Access Compliance Report

Public Rights-of-Way

Intersection ID: 2771	Main Street: MAYAPPLE_LN	Cross Street: RIDGEFIELD_DR	Location:	N
ADA ID: BE061552604F	Ramp Type: Perp	Initial Pass/Fail: Fail	Overall Compliance: No	Severity Score: 35
Codes/Mitigation Info/Possible Solution		Field Measurements/Component Compliance

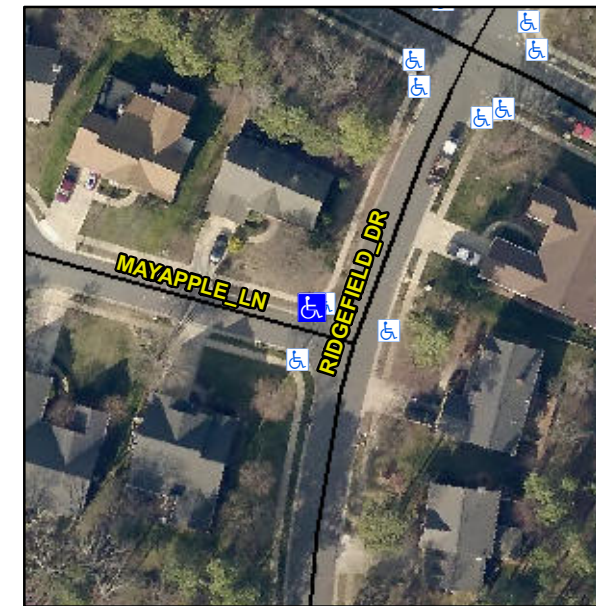
R304.5.1, R304.2.2, R304.5.3

Compliance	Description	Data	Compliance	Description	Data
N/A	Ramp Length (in)	44.0	No	Ramp Slope (%)	12.2
No	Ramp Width (in)	39.0	No	Ramp XSlope (%)	3.2
N/A	Flare Type LT	N/A	N/A	Flare Type RT	N/A
N/A	Flare Slope LT (%)	N/A	N/A	Flare Slope RT (%)	N/A
N/A	Flare Traversable LT?	N/A	N/A	Flare Traversable RT?	N/A
N/A	Landing Length (in)	N/A	N/A	DWS Provided?	N/A
N/A	Landing Width (in)	N/A	N/A	DWS Contrast?	N/A
N/A	Landing Slope (%)	N/A	N/A	DWS Length (in)	N/A
N/A	Landing X Slope (%)	N/A	N/A	DWS Full Width?	N/A
N/A	Landing Curb? (Y/N)	N/A	N/A	DWS Offset (in)	N/A
N/A	Shared Landing?	N/A			
N/A	Gutter Ponding?	N/A	N/A	Gutter Slope (%)	N/A
N/A	Gutter Lip Ht (in)	N/A	N/A	Gutter X Slope (%)	N/A
N/A	Painted X Walk1?	No	N/A	Painted X Walk2?	N/A
	X Walk 1 Direction	To SW		X Walk 2 Direction	N/A
N/A	X Walk 1 Width (in)	N/A	N/A	X Walk 2 Width (in)	N/A
	X Walk 1 Slope (%)	0.4		X Walk 2 Slope (%)	N/A
	X Walk 1 X Slope (%)	3.1		X Walk 2 X Slope (%)	N/A

Remove & Replace Entire Ramp.
